Examination of the Tunbridge Wells Borough Local Plan

**Local Plan Examination Note for
Inspector in response to Action Point 18
regarding Policy AL/HO 2: Land south
of Brenchley Road and west of
Fromandez Drive**

Document Reference: TWLP/097

Date: 31 August 2022

Drawing Title:
PROPOSED FOOTWAY OPTION 1 - 6m WIDE CARRIAGEWAY WITH A 1.2m FOOTWAY TO THE SOUTH

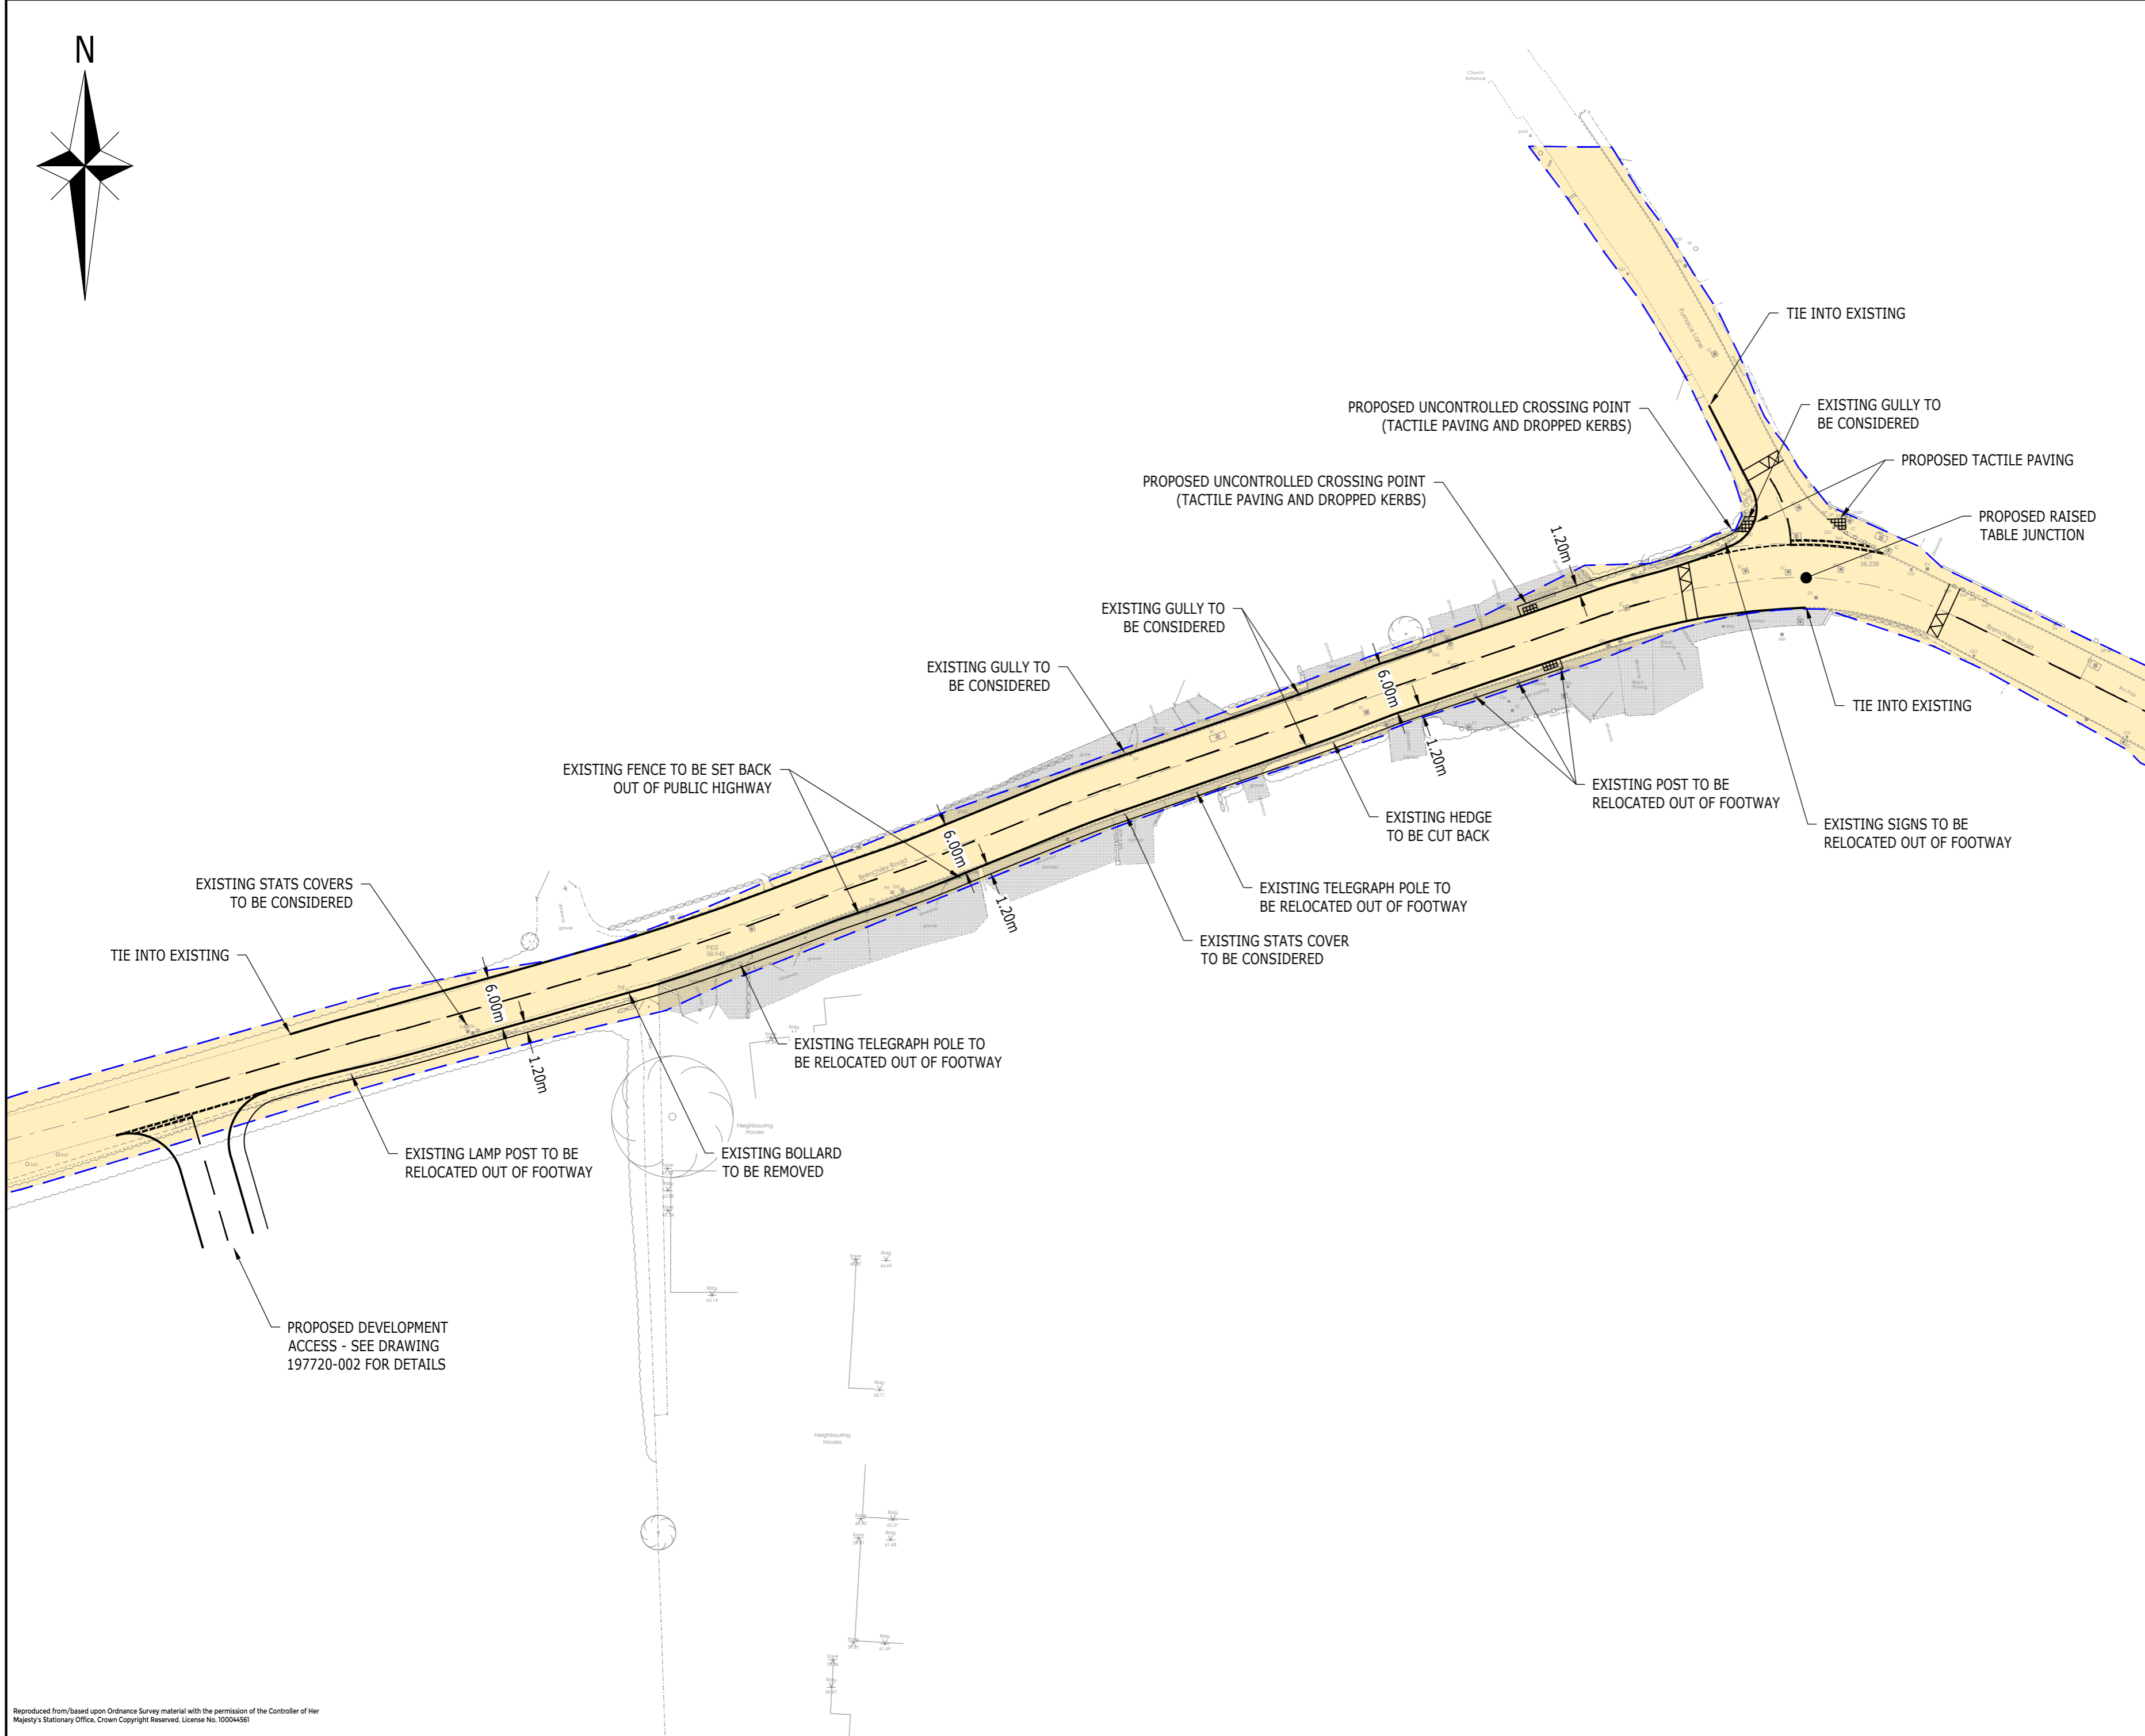
- 2.11 At **Appendix 1** of this Note, is a plan that the agent acting on behalf of the applicant for the site, has shared with the Council. It is drawing number 197720-008 dated 12 November 2021, which shows an option for the provision of a footway along Brenchley Road, linking the site the existing footway network to the east. This Plan, which has been informed by topographic survey, demonstrates that there is scope within the existing highway boundary to provide for minimum carriageway and footway widths to serve the site (this is discussed in further detail at paragraph 2.15 below). The agent is yet to submit this formally to the Council/KCC Highways for consideration pending other further work to support the current planning application.

I can confirm that KCC H&T have no objection to the allocation of this site at Brenchley Road, Horsmonden (AL/HO2) subject to the delivery of a footway of minimum width of 1.2m and a carriageway minimum width of 6m between the development and the existing footway on the north side of Brenchley Road, east of its junction with Furnace Lane and including a pedestrian crossing facility on Brenchley Road. The footway and crossing are required prior to commencement of development. The applicant is required to provide a Transport Statement including drawing/s of an appropriate scale, including a scale bar, showing how the footway can be provided within the highway boundary and clearly identifying areas where enforcement measures will be needed, with dimensions included. The drawing shall be based on a topographical survey and provided at the same scale as the topographical survey. A stage 1 safety audit for the new site access and off-site highway works is also required.

4. Development proposals for the site shall include the provision of a 1.2 metre minimum width footway whilst maintaining a 6 metre minimum width carriageway, between the site and Furnace Lane, to link with the existing footway east of Furnace Lane to the site. The proposals shall also include provision of safe crossing facilities on Brenchley Road; Provide a pedestrian access from the site along Brenchley Road to link with the wider footway network;
